RE: A006761597/198 & 202 GARDNER ROAD, ROCHEDALE, 4123 - RESPONSE TO INFORMATION REQUEST

Applicant	Gardner Road Developments Pty Ltd C/- The Development Directive Pty Ltd
Land Owner	Gardner Road Developments Pty Ltd
Application Number	A006761597
Application Address	198 & 202 Gardner Road, Rochedale, 4123

Figure 1: Development Pad as proposed at lodgement.

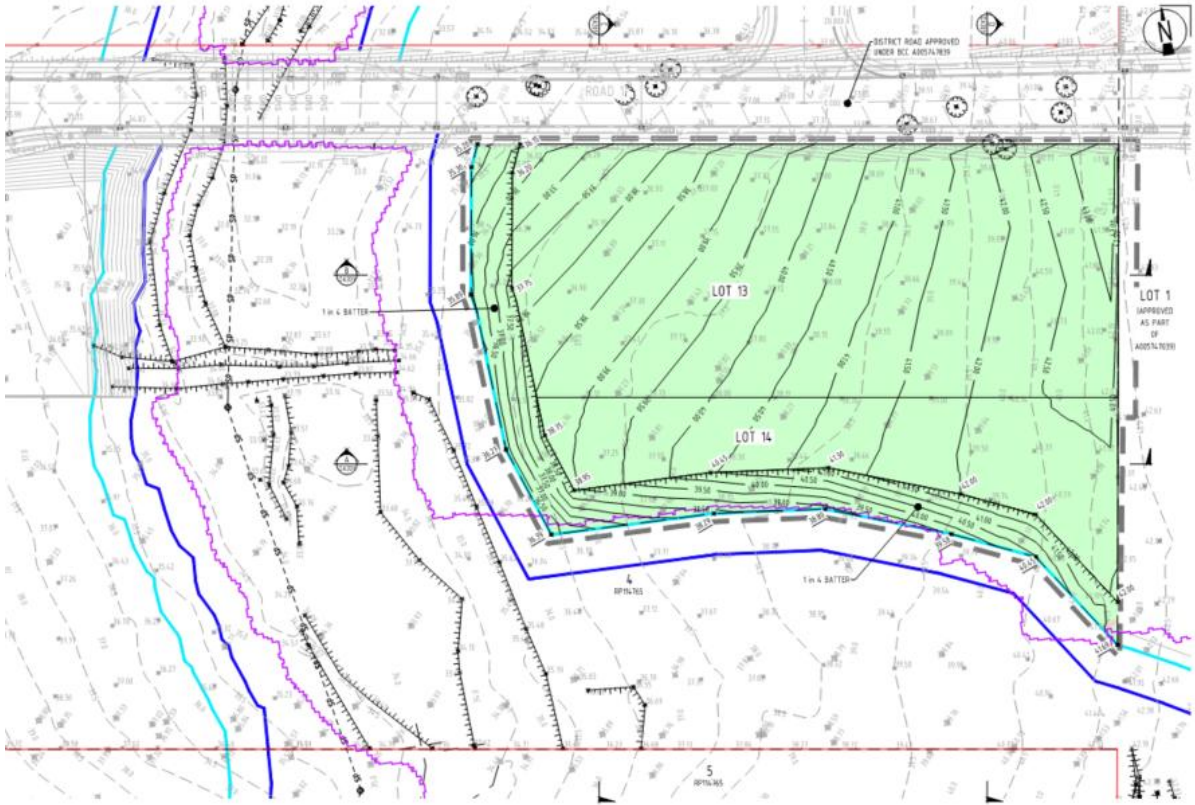
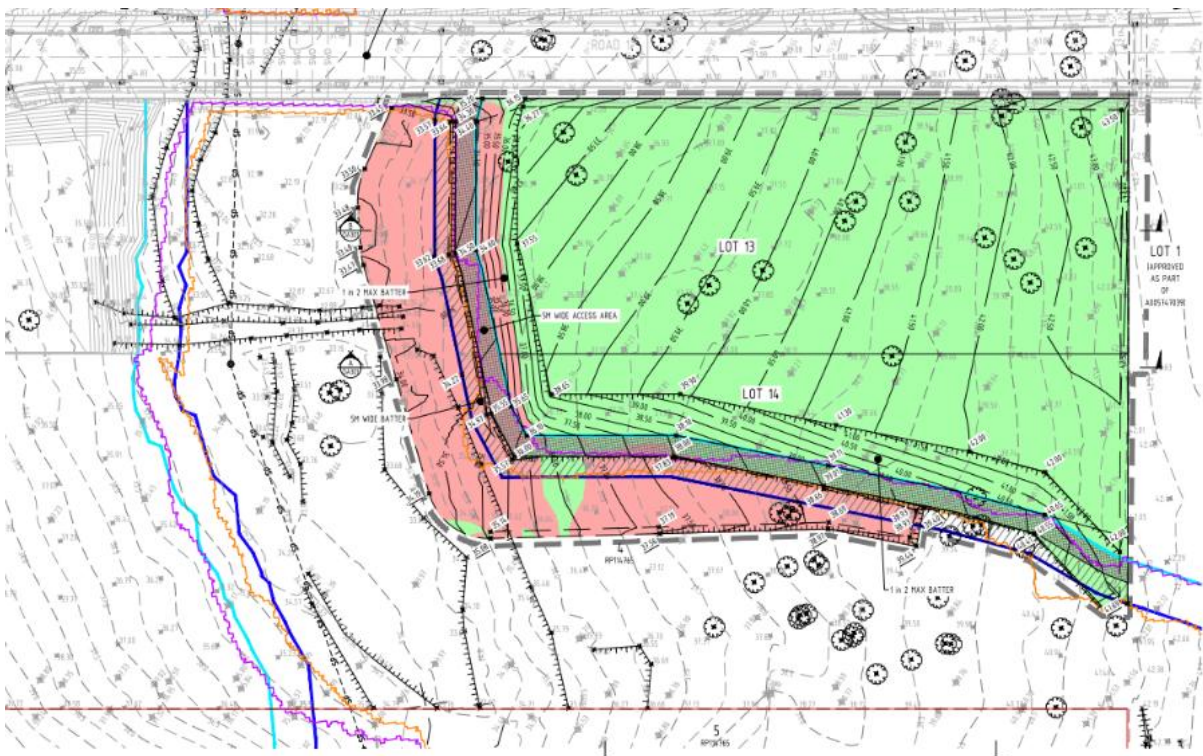
5. While the proposal seeks realignment of the waterway corridor centreline, this varying of the trunk waterway corridor and overlays must not compromise the values of the ultimate LGIP waterway corridor on adjoining land parcels. Submit an amended layout and demonstrate how the development will not worsen flooding impacts and not compromise achieving an 80m waterway corridor width in accordance with LGIP requirements and as required by PO3 and PO10 of the Subdivision code.

Please find within Attachment 5 an updated Flood Impact Assessment (FIA) prepared by ADG Engineers. Please also find within Attachment 6 an updated Civil Plans package prepared by ADG Engineers, which has slightly amended the design of the development pad. Refer to Figure 1 and 2 below.

The developable land as now proposed by the application has been reduced in size by circa 550m², as summarised in Table 1 below. Inversely the Waterway Lot has increased by +550m².

The reason for the revised design to the development lots (and resultant changes to lot size) is a result of a change to the flood modelling inputs (as compared to the approved FIA as part of A005747839). These changes include:

- To reflect revised rainfall data within the flood model (as compared to that which was relevant at the time A005747839 was approved); and
- an increased mannings roughness coefficient (which has been increased from 0.1 under the approved FIA as part of A005747839 to 0.15 per the rehabilitation outcomes sought for the Waterway).

The resultant changes to the earthworks of the site include:

- “pulling back” of extent of filling to increase the waterway width; and
- Introducing an area of shallow cut at the junction of the waterways to assist the meandering of water around the bend of the waterway in flood events. This area of cut is very shallow (less than 500mm) and will be planted out in accordance with the proposed Concept Rehabilitation Plan.

Additionally, the Waterway Fringe has been reshaped to remove battering and to provide a finished surface level which is appropriate for the construction of the trunk bikeway, above the 39% AEP flood line.
